ADDENDUM NO. 1 TO PROJECT NO. 43307

**CONSTRUCTION WORK
MARCELL ROTH DAM REHABILITATION
PHASE III DESIGN AND CONSTRUCTION
TOWN OF KENT
PUTNAM COUNTY, NY**

July 2, 2013

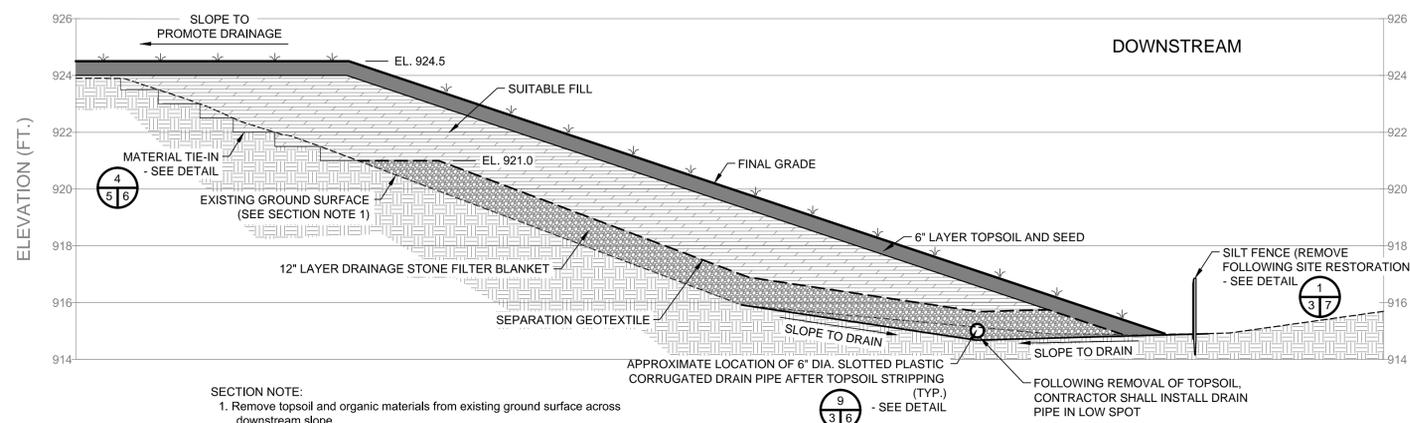
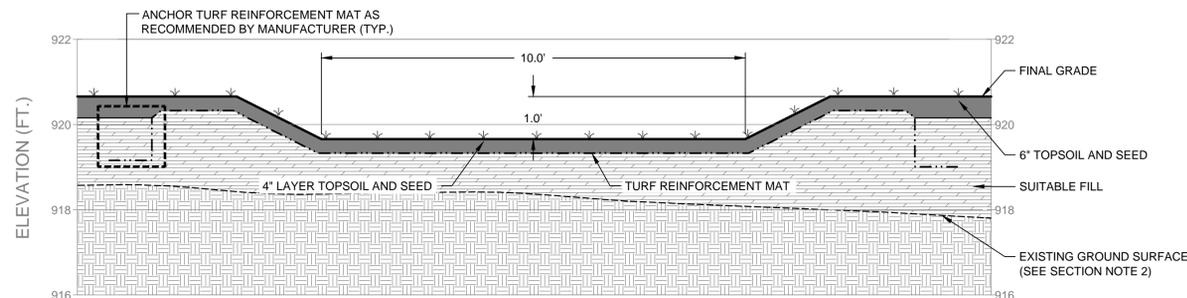
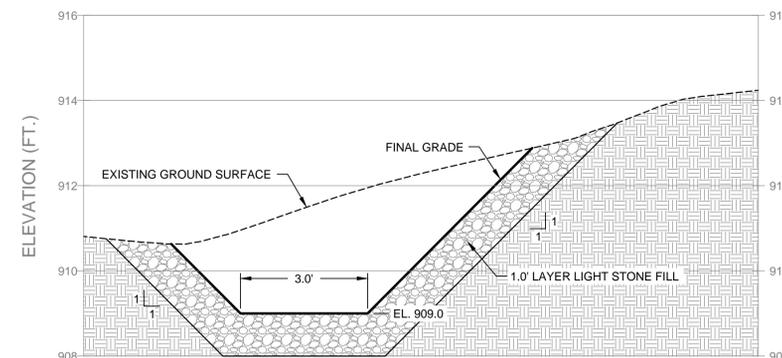
- 1. Section 2/3/5, Section 3/3/5, and Section 4/5/5: The turf reinforcement mat has been moved beneath the topsoil layer.
- 15. Revised Drawing:
 - a. Drawing No. D-502 (Sheet 6 of 12), noted “REVISED DRAWING 7/2/2013” accompanies this Addendum and supersedes the same numbered originally issued drawing.

D-502

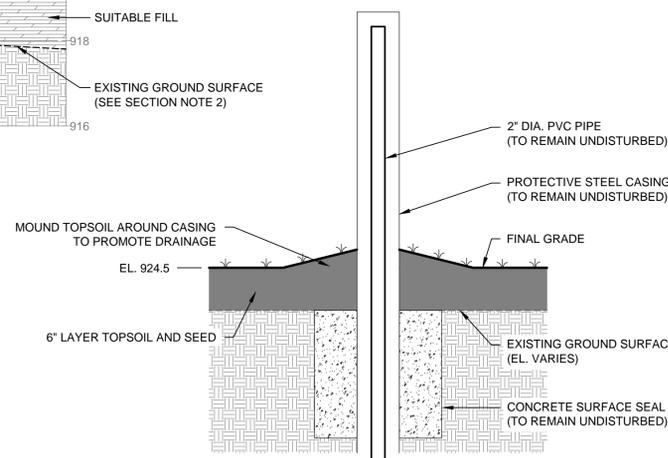
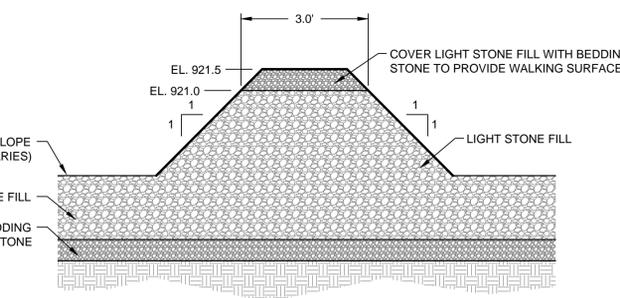
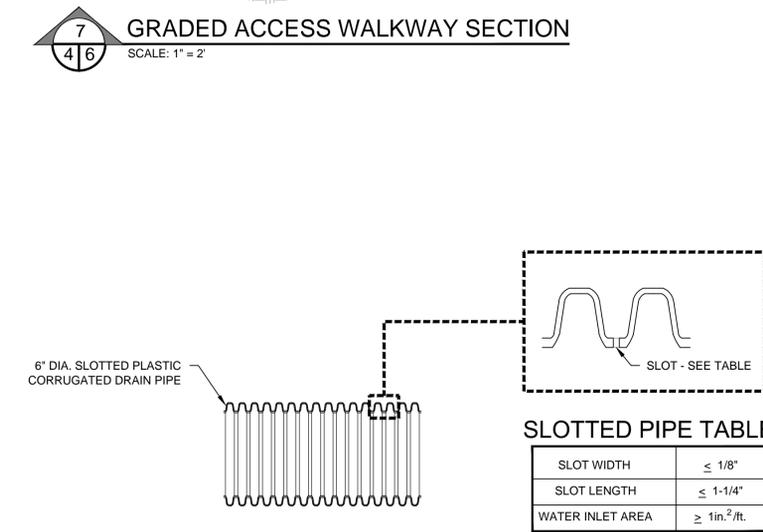
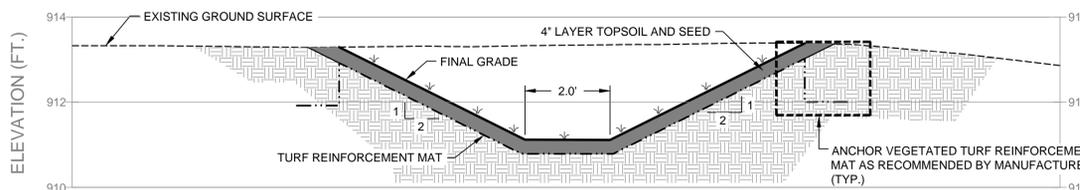
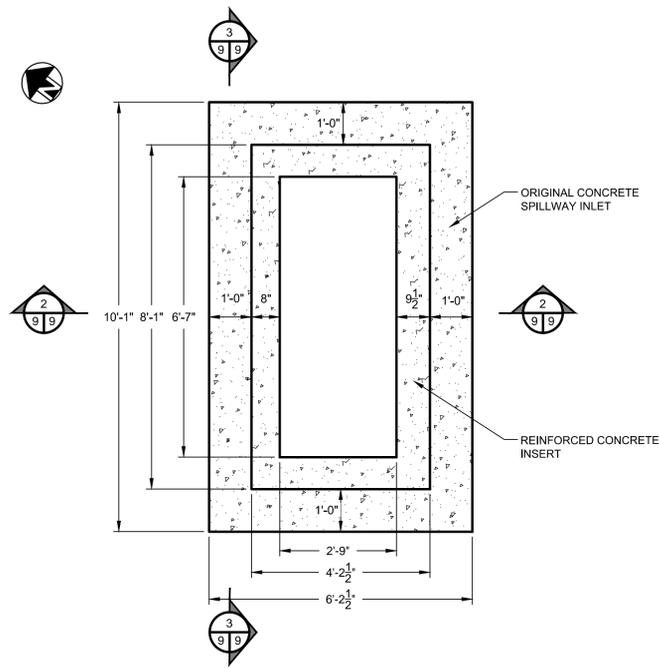
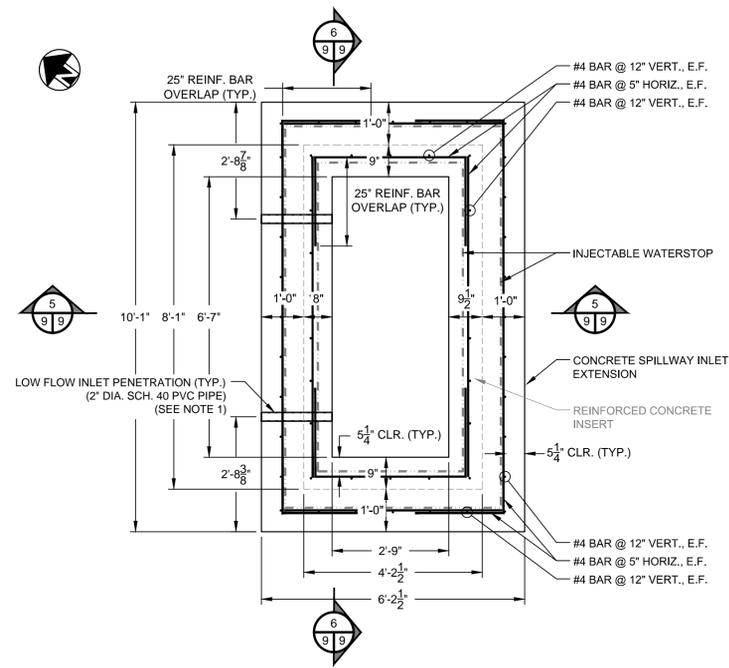
- 1. Section 3/3/6 and Section 5/3/6: The turf reinforcement mat has been moved beneath the topsoil layer.
- 16. Revised Drawing:
 - a. Drawing No. D-505 (Sheet 9 of 12), noted “REVISED DRAWING 7/2/2013” accompanies this Addendum and supersedes the same numbered originally issued drawing.

D-505

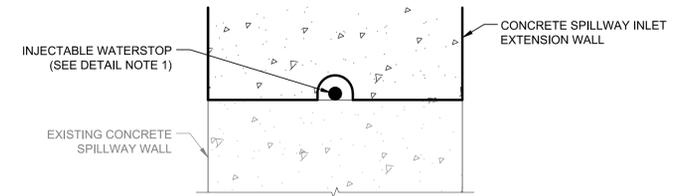
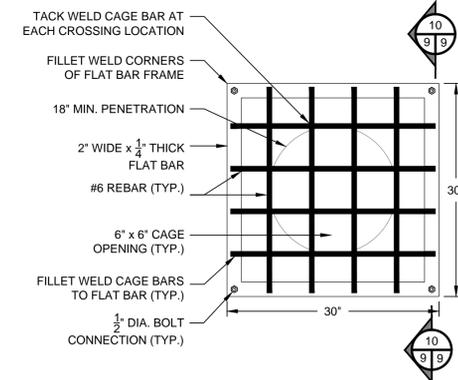
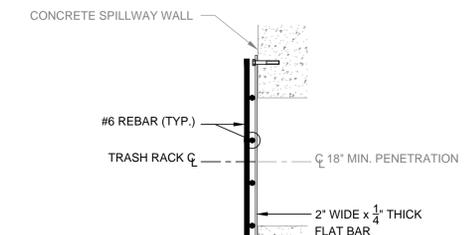
- 1. Detail 4/4/9, Section 5/9/9, and Section 6/9/9: 2-inch diameter Schedule 40 low flow penetration pipes have been added to the spillway inlet extension.

3. Page 033000-5, Article 2.01, Add the Following Paragraph:
“L. Low Flow Penetrations: Schedule 40 PVC pipe to the size and dimensions shown on the Contract Drawings.
 1. The pipe penetrations shall be located as shown on the Contract Drawings.”
4. Page 055000 – 2, Change Paragraph 1.04 B. to Read:
“B. At least 4 weeks prior to the planned start date, submit shop drawings showing the dimensions of the railings, railing extent, base plate, and connection details required to complete the work.”
5. Page 055000 – 3, Paragraph 2.01 B.5: Delete this paragraph in its entirety.

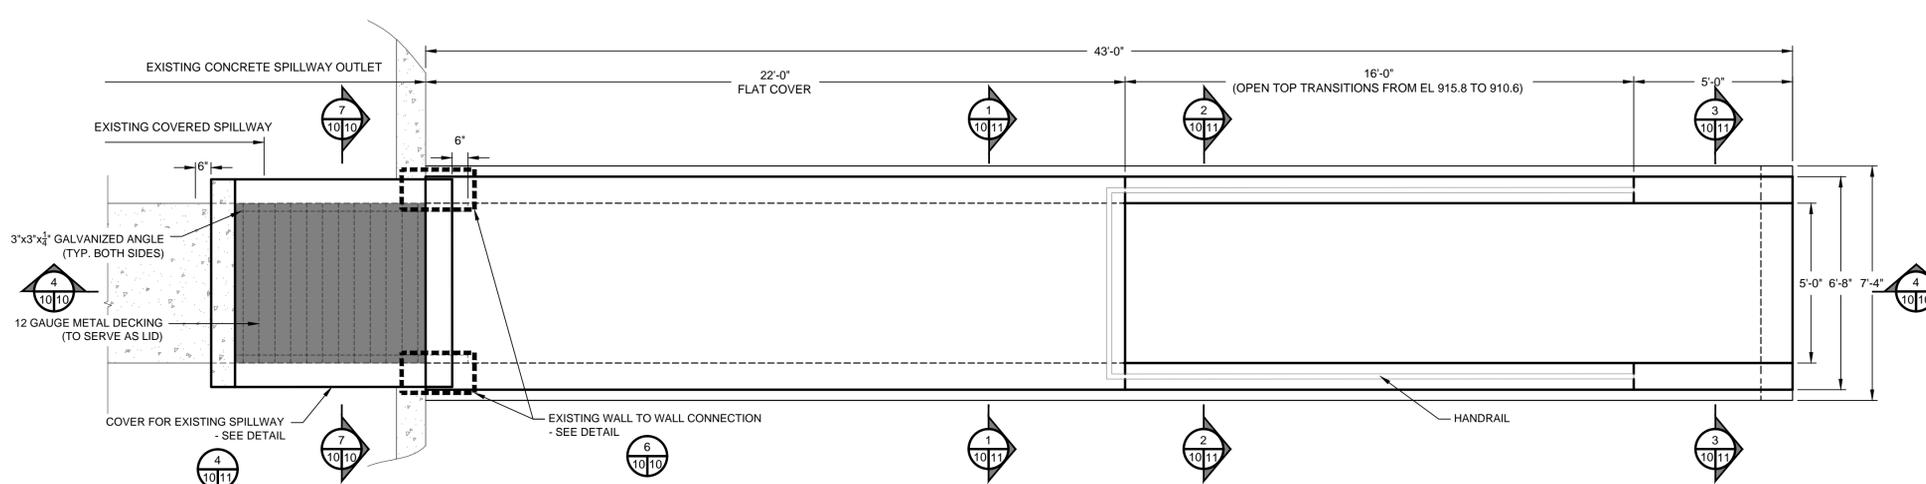
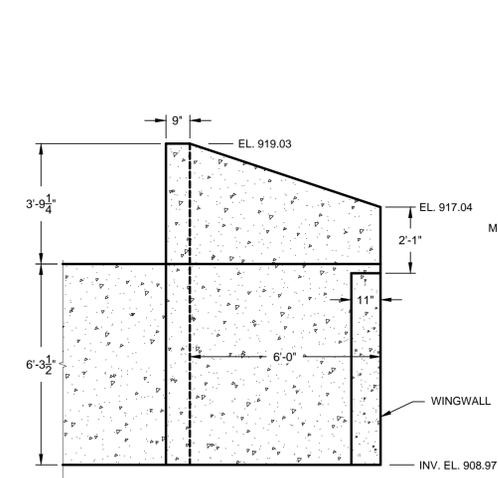
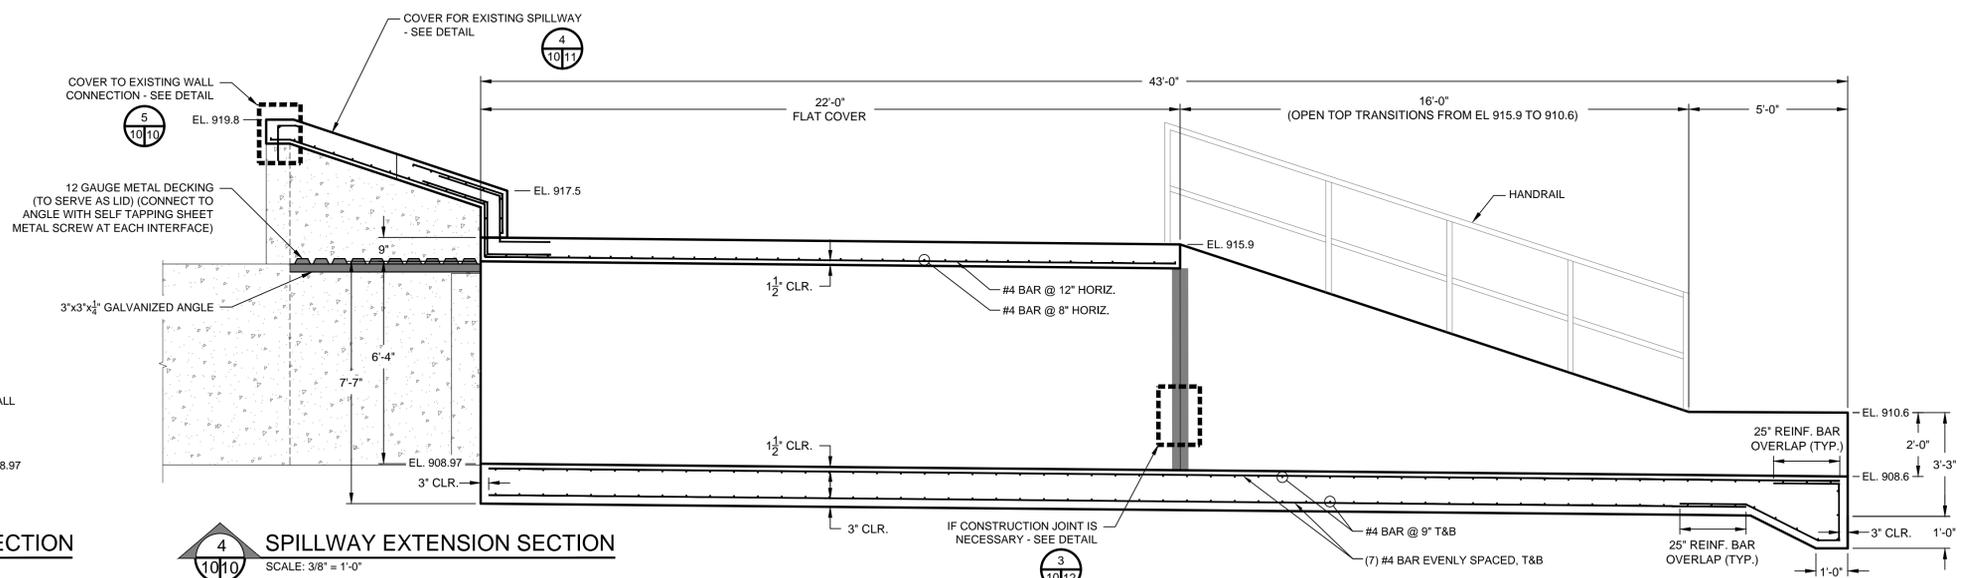
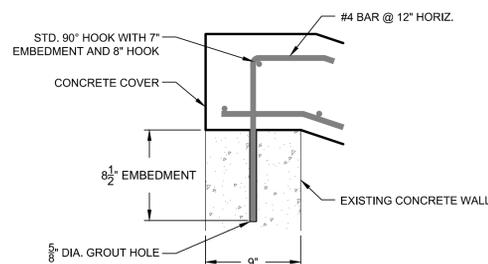
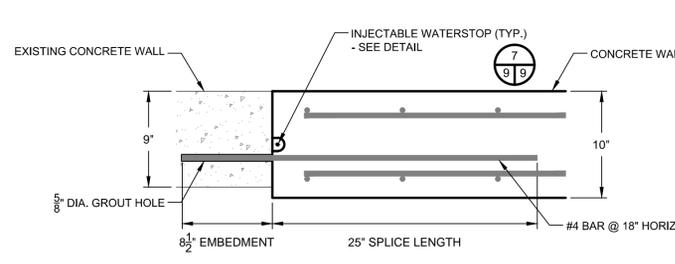
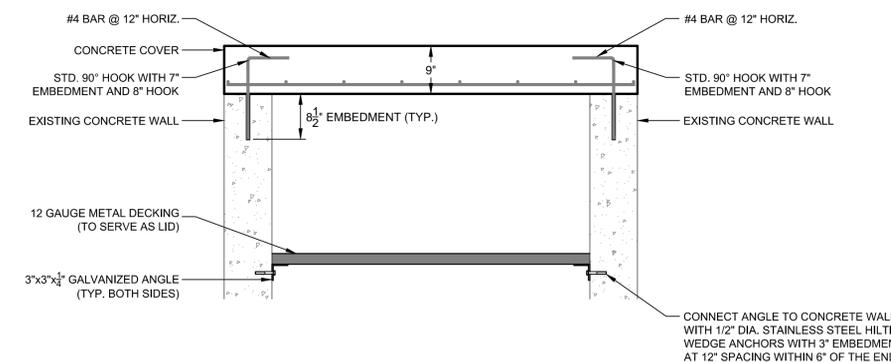
- 1. Detail 2/4/10, Section 4/4/10, and Section 7/10/10: The lid has been revised from 20 gauge to 12 gauge metal decking.
- 18. Revised Drawing:
 - a. Drawing No. D-507 (Sheet 11 of 12), noted “REVISED DRAWING 7/2/2013” accompanies this Addendum and supersedes the same numbered originally issued drawing.

6. Page 055000 – 4, Paragraph 2.03 A:
Replace 20 gauge with 12 gauge metal decking.
7. Page 055000 – 4, Change Paragraph 2.03 C. to Read:
“C. Metal decking should be fastened to framing with stainless steel self-tapping sheet metal screws installed at each rib contact.”

5 COVER FOR EXISTING SPILLWAY SECTION
SCALE: 3/4" = 1'-0"

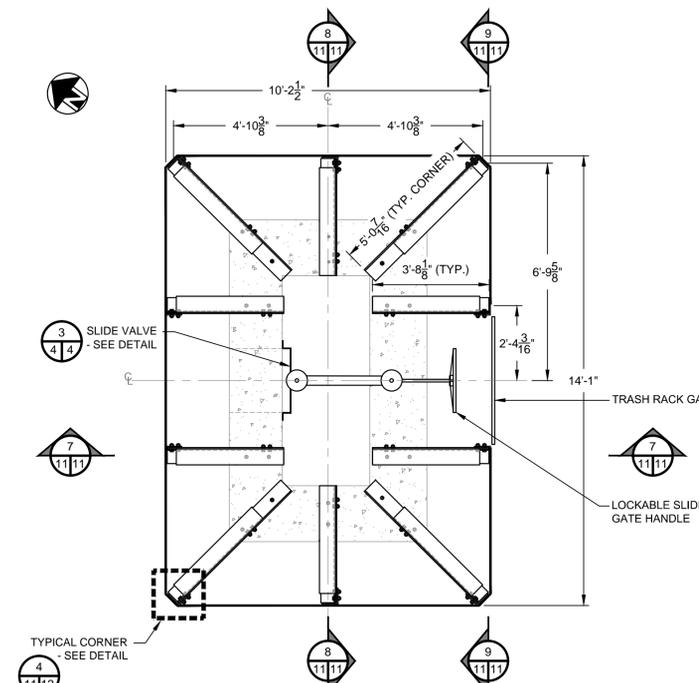
- 1. Section 5/11/11: The lid has been revised from 20 gauge to 12 gauge metal decking.
